# PLANNING AND ZONING COMMISSION MEETING

City Council Chambers, 33 East Broadway Avenue Meridian, Idaho  
Thursday, November 18, 2021 at 6:00 PM

## STAFF REPORT COMMUNITY DEVELOPMENT DEPARTMENT

# STAFF REPORT

#### A. Proposed Concept Plan (date: 10/14/2021) (NOT APPROVED)

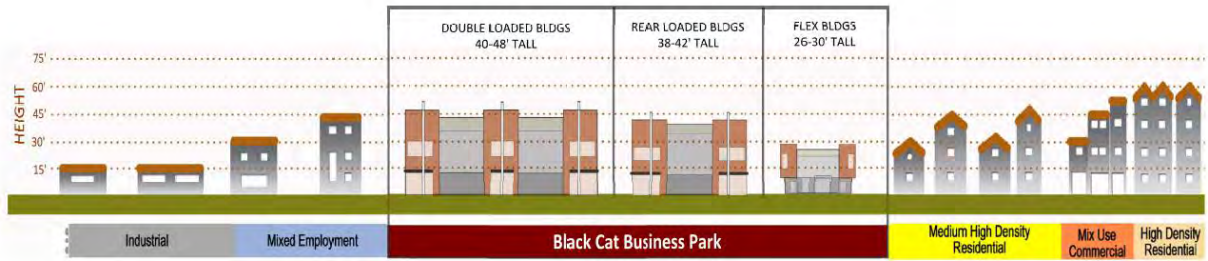
With some revisions, staff believes Buildings K1-M1 as shown on the concept plan could mostly reflect these principles, although the buildings are oriented around a central parking lot rather than a courtyard. Also, the TMISAP mentions building frontages, rather than surface parking lots and landscaped areas, should "hold the corners" by framing sidewalks or public spaces whereas the entrance of this development from S. Black Cat Rd consists of landscaping and parking lots with building maintaining larger setbacks.

The larger buildings A-J are oriented to a wide collector street, have larger front setbacks, have single building frontages between 180 ft. and 470 ft. in length, and are not broken down or wrapped with smaller buildings. Staff does not believe this encapsulates the TMISAP principals for design envisioned for this area and is skeptical the concept plan could be designed to meet these principles for the use as proposed. **The Planning Commission and City Council should decide whether this type of industrial use is appropriate in this area.**

D. Landscape Plan Marked Up with Recommended Pathway Connections (date: 9/9/2021)

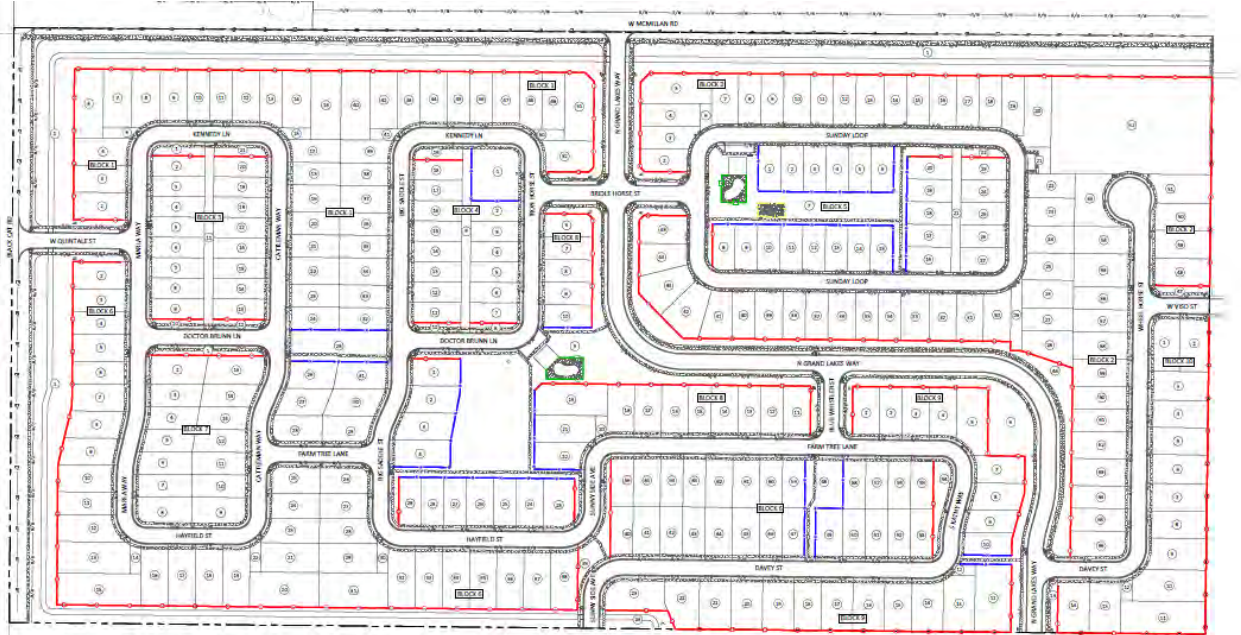
C. Color Landscape Plan with Recommended Pathway Connections (date: 9/9/2021)
